DEVELOPMENT APPLICATION ASSESSMENT REPORT

Application Number:	DA2024/1089
----------------------------	-------------

Responsible Officer:	Thomas Burns
Land to be developed (Address):	Lot 1 DP 951859, 1289 Pittwater Road NARRABEEN NSW 2101
Proposed Development:	Alterations and additions to a dwelling house to create a residential flat building comprising of three (3) units.
Zoning:	Warringah LEP2011 - Land zoned R3 Medium Density Residential
Development Permissible:	Yes
Existing Use Rights:	No
Consent Authority:	Northern Beaches Council
Land and Environment Court Action:	No
Applicant:	Rapid Plans Pty Ltd

Figure 1 - private open space configuration for ground floor apartments

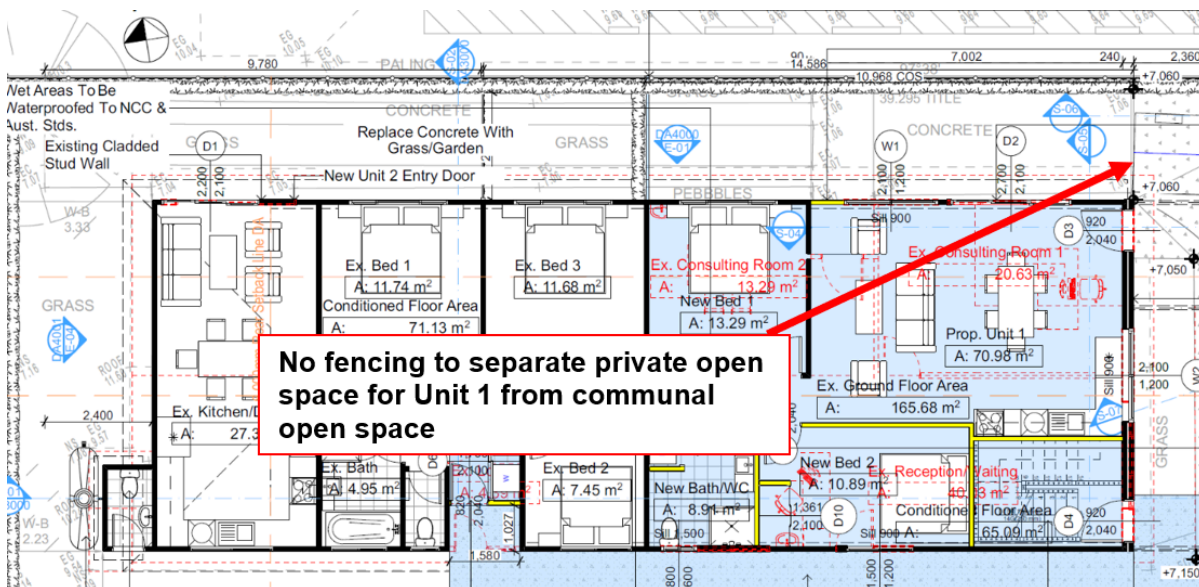
Section D2 of the WDCP requires that each apartment contain 10sqm of private open space (POS) with a minimum dimension of 2.5m. Units 2 and 3 within the development contain compliant POS; however, Unit 1 does not contain any POS, given there is no fencing that separates the POS from the common areas of the site (see **Figure 1**).

Figure 3 - strata plan depicting location of private open space for ground floor apartments at 1283-1287 Pittwater Road

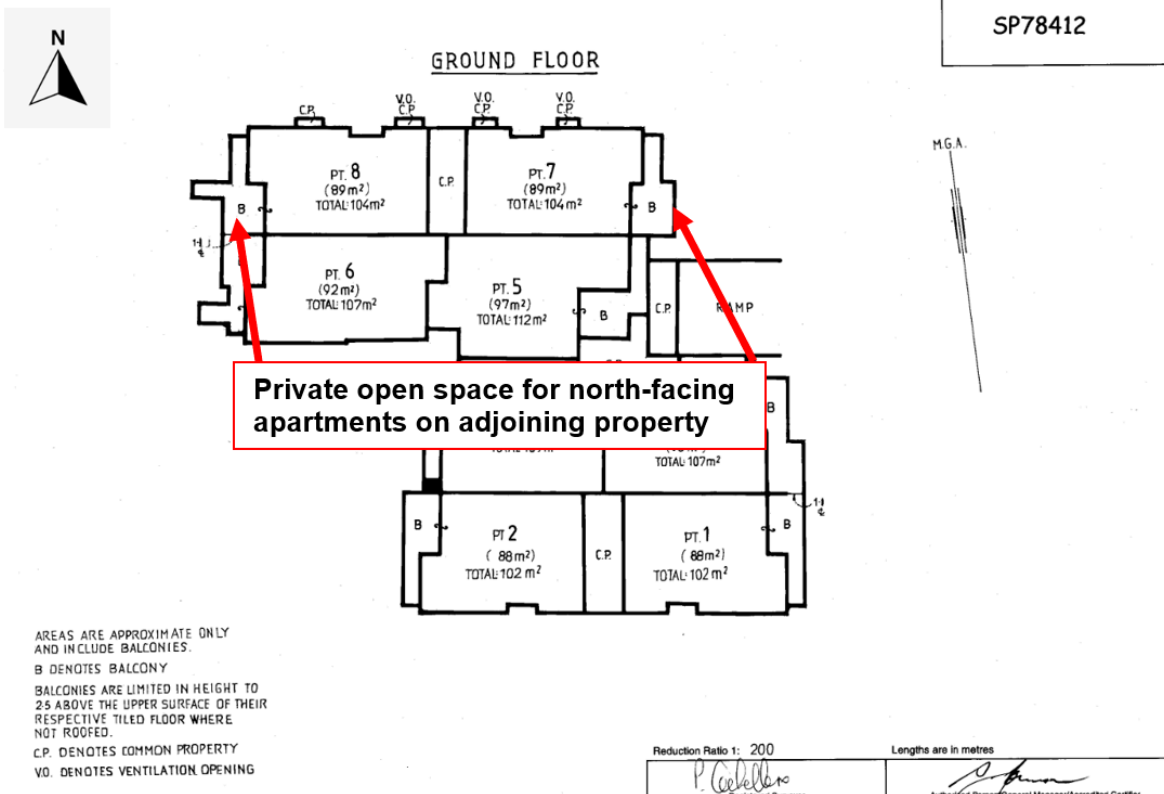
Despite this, a review of the strata plan for the southern adjoining residential flat building has revealed that the private open space for the north-facing apartments is located on the eastern (i.e. front) and western (i.e. rear) elevations (see **Figure 3**).

The shadow diagrams reveal that these areas will receive the required 3 hours of sunlight on June 21 and therefore, the development complies with Section D6 of the WDCP.
